DEVELOPMENT ASSESSMENT REPORT	
<b>Application No.</b>	DA/2020/1146
<b>Address</b>	152-156 Parramatta Road STANMORE NSW 2048
<b>Proposal</b>	Substantial demolition of existing improvements, retention of existing building facade and construction of a 5 storey boarding house containing 34 single boarding rooms, 1 managers room and 2 ground floor commercial tenancies
<b>Date of Lodgement</b>	23 December 2020
<b>Applicant</b>	Alain Assoum
<b>Owner</b>	Stenta Pty Ltd
<b>Number of Submissions</b>	Initial: 21 After Renotification: 1
<b>Value of works</b>	\$3,735,653.00
<b>Reason for determination at Planning Panel</b>	Variation to height and FSR development standards exceeds 10% Number of submissions
<b>Main Issues</b>	Lack of Clause 4.6 written request Exceedance of Height and FSR and resultant bulk and scale impacts Parking
<b>Recommendation</b>	Refusal
<b>Attachment A</b>	Reasons for refusal
<b>Attachment B</b>	Plans of proposed development

This report is an assessment of the application submitted to Council for substantial demolition of existing improvements, retention of existing building facade and construction of a 5 storey boarding house containing 34 boarding rooms, 1 managers ro

Figure 3: Submitted GFA Diagrams with Council officer calculations shown.

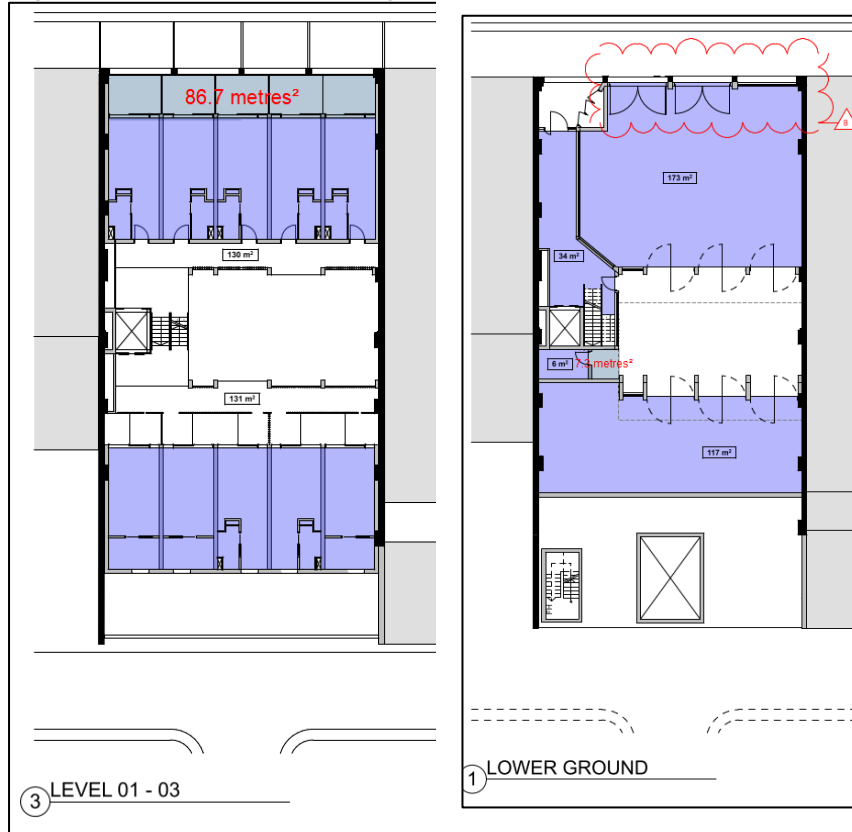
Note: the discrepancy in relation to the Council’s GFA calculation exceeding the applicant’s calculation relates to the applicant excluding the enclosed balconies/terraces for the north facing boarding rooms facing Parramatta Road on levels 01 and 02. Council’s calculation includes these areas given they have enclosing walls and roof above 1.4m as per the definition of gross floor area under *MLEP 2011*. A small area on the roof terrace and lower ground floor are included for similar reasons. These areas of difference are highlighted in light blue in figures 3 & 4 below.

Figure 5: Section Plans with Height Exceedance highlighted in yellow

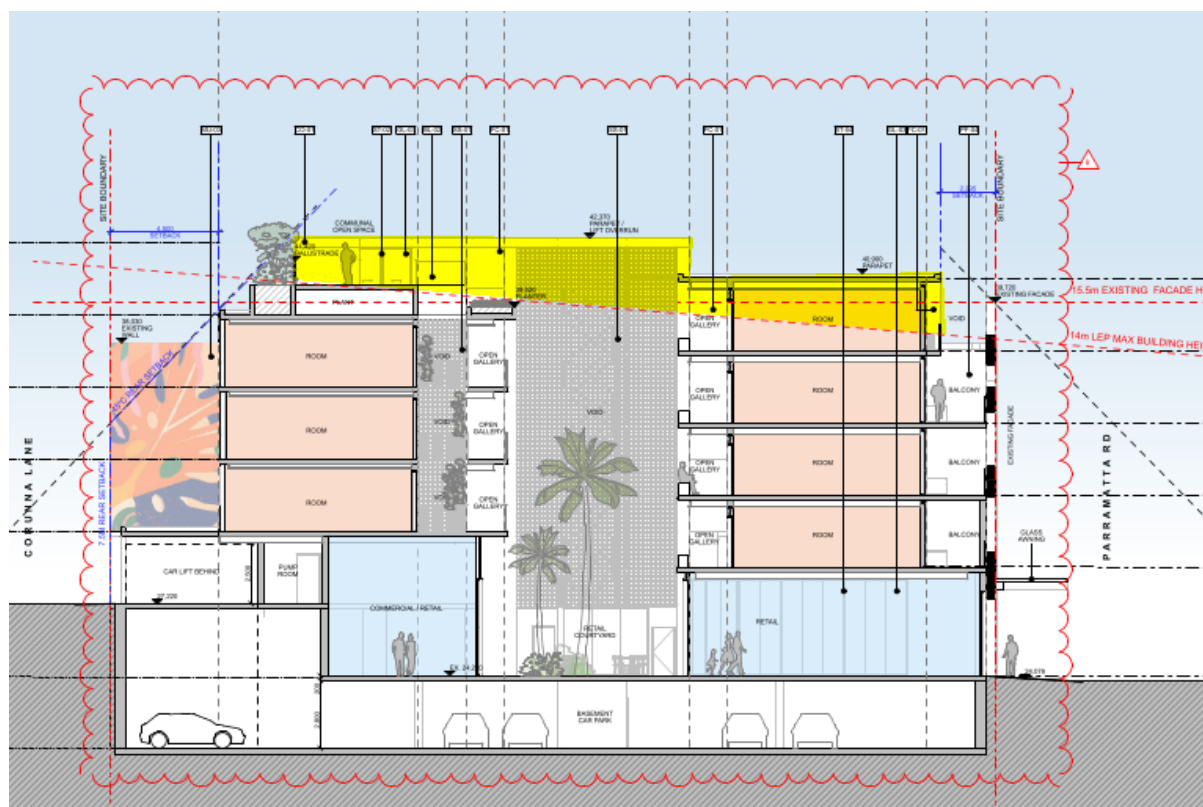
The justification for the exceedance to the height limit on the basis that if a compliant development was proposed then the rooftop communal space would not be provided is not accepted. The addition of level 04 being the fifth level of the building exceeds all the recently approved developments as outlined earlier in this report by a storey. It presents as a five-storey building to both Parramatta Road and Corunna Lane which contravenes the DCP controls for the site. The additional floor fronting Paramatta Road has no bearing on the provision of a rooftop communal area as indicated as the majority of the habitable floor exceeds the height limit in this portion of the building. The majority of the top level exceeds the height limit as illustrated in figures 5 and 6 below.

The proposal when considered in the context of the significant breach of the maximum floor space for the site, represents an overdevelopment of the site and the justification that the height exceedance is limited to a parapet for the lift overrun is false.

Figure 8: Section showing line of sight prepared by applicant with Council measurements

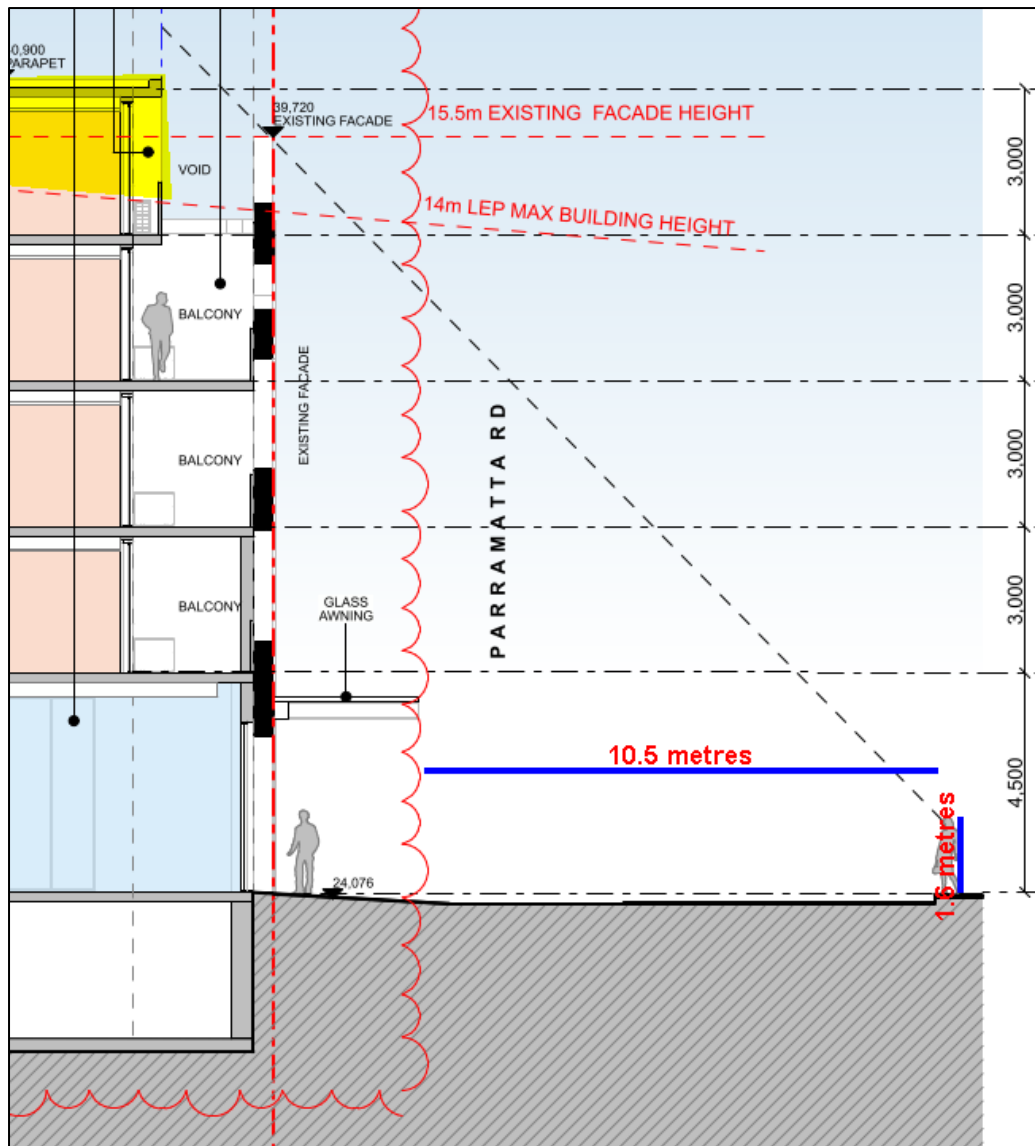
The applicant has attempted to demonstrate the visibility of the additions; however, the drawing provided as shown in figure 8 is inaccurate as the distance provided of 10.5 metres is half the actual width of Parramatta Road and the height of the direct sight line is only 1.6 metres above the footpath level not 1.8 metres as required by the control. It has not been demonstrated that the fifth floor would not be visible as required. There have been no

attempts to comply with the control or reduce the visibility of the top floor through the increase of side and front setbacks and consequently as illustrated in figure 9, the additions sit well above the period façade and pitched parapet resulting in an unsympathetic addition to the period building. Additionally as the adjoining sites are largely undeveloped with low parapets, the top most level which is proposed to be constructed to the side boundaries will be highly visible.
